SHINE TECHNOLOGIES, LLC

SHINE TECHNOLOGIES, LLC APPLICATION FOR AN OPERATING LICENSE SUPPLEMENT NO. 13 AND RESPONSE TO REQUEST FOR ADDITIONAL INFORMATION

RESPONSE TO REQUEST FOR ADDITIONAL INFORMATION PUBLIC VERSION

RAI 7-20

Figure 7.4-1 TRPS Logic Diagrams
(Sheet 8 of 14)

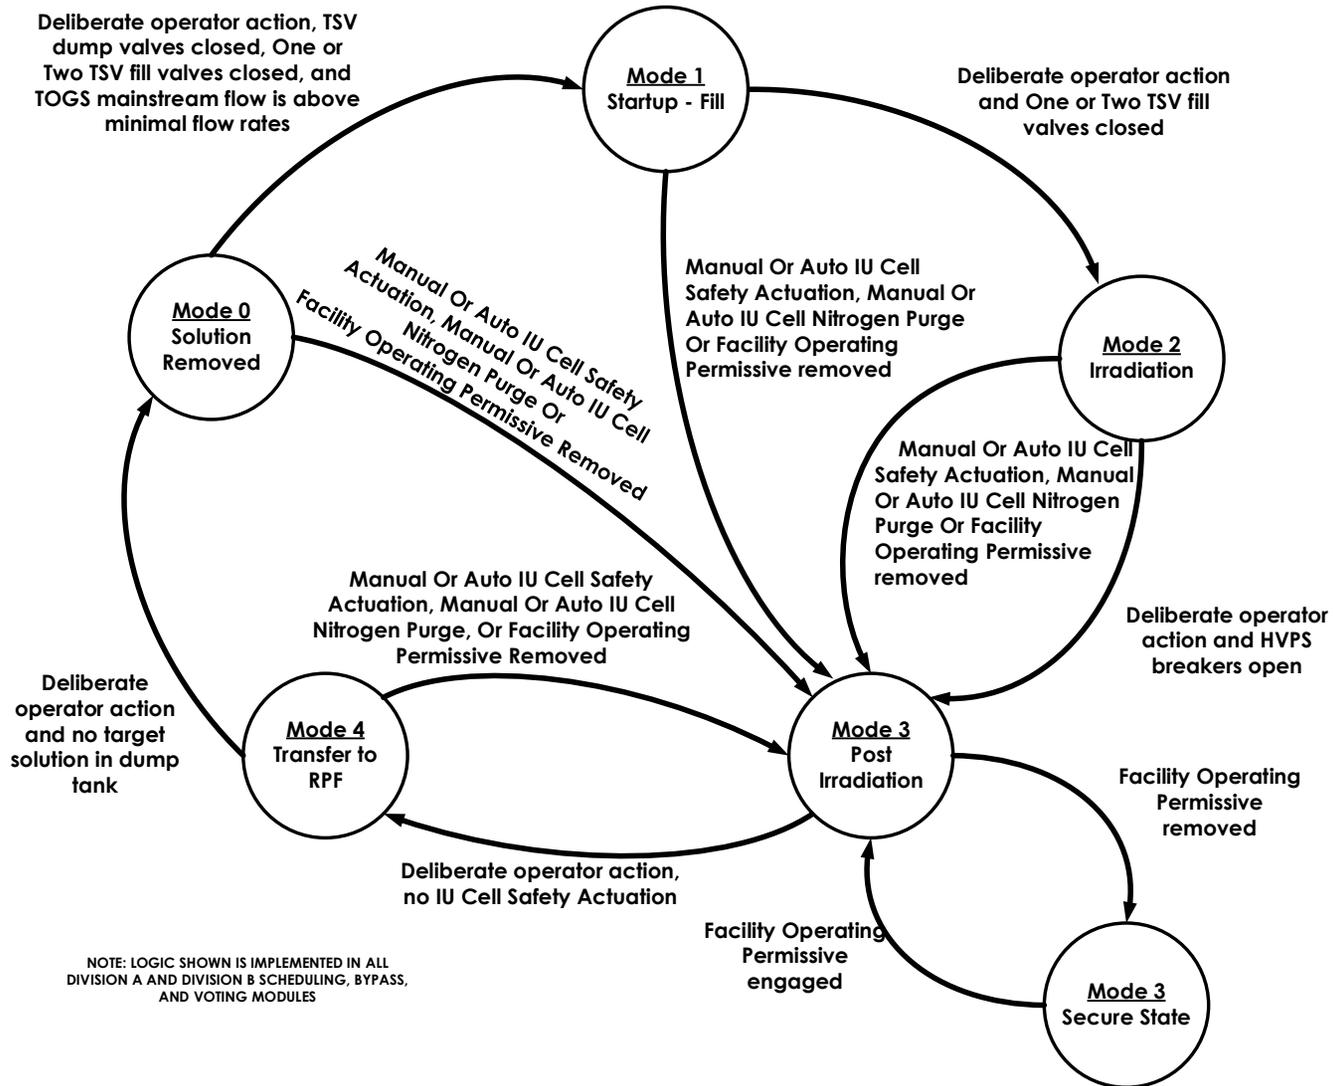
SHINE FSAR Section 7.4.3.4, "Single Failure," describes the operational use of the "safety-related enable nonsafety switch" and the logic for this switch is depicted in Figure 7.4-1, "TRPS Logic Diagrams," Sheets 12 and 13. However, during the May 2021 regulatory audit, SHINE stated that this description and depiction was not accurate and would be revised.

Update the SHINE FSAR to clarify the function allocations within the TRPS and ESFAS, ensuring consistency between the SHINE FSAR and TSs. In particular, as requested in item (c) above, identify the functions only assigned to Division A. Also, update the SHINE FSAR to provide allocation and differences of safety functions to each SFM (which is a TRPS channel) for their implementation at the gate level.

Revise the SHINE FSAR to describe the logic used to generate discrete signals from analog signal inputs to the TRPS and ESFAS, as well as the logic used to implement operational and maintenance bypass and permissives. Also, revise the FSAR to describe how monitored signals are input to the TRPS and ESFAS, conditioned, and evaluated against defined setpoints in the safety function module (i.e., the logic to generate safety signals).

Revise the SHINE FSAR to describe the design and configuration of the facility master operating permissive. Include all inputs to be used by the TRPS and ESFAS to perform its functions (also see items (a)(1) and (a)(2) for RAI 7-20 above).

- (d) SHINE has revised Figures 7.4-1 and 7.5-1 of the FSAR to depict the allocation of safety functions, via allocation of inputs, to each safety function module (SFM). Revisions to these figures incorporating these changes are provided in Attachment 1.

SHINE has revised Figures 7.4-1 and 7.5-1 of the FSAR to identify in which highly integrated protection system (HIPS) module each safety function is performed. SHINE has also revised Subsections 7.4.3.11 and 7.5.3.10 of the FSAR to describe how discrete signals are generated from analog signal inputs to the TRPS and ESFAS and to describe how monitored signals are input, conditioned, and evaluated against defined setpoints in the SFM. A markup of the FSAR incorporating these changes is provided as Attachment 1.

SHINE has revised Subsections 7.4.3.1.3, 7.4.3.1.4, 7.4.3.2, 7.4.4.1.18, 7.4.4.2, and 7.5.4.3 of the FSAR and Figures 7.4-1 and 7.5-1 of the FSAR to enhance the description of the facility master operating permissive switch. A markup of the FSAR incorporating these changes is provided as Attachment 1.
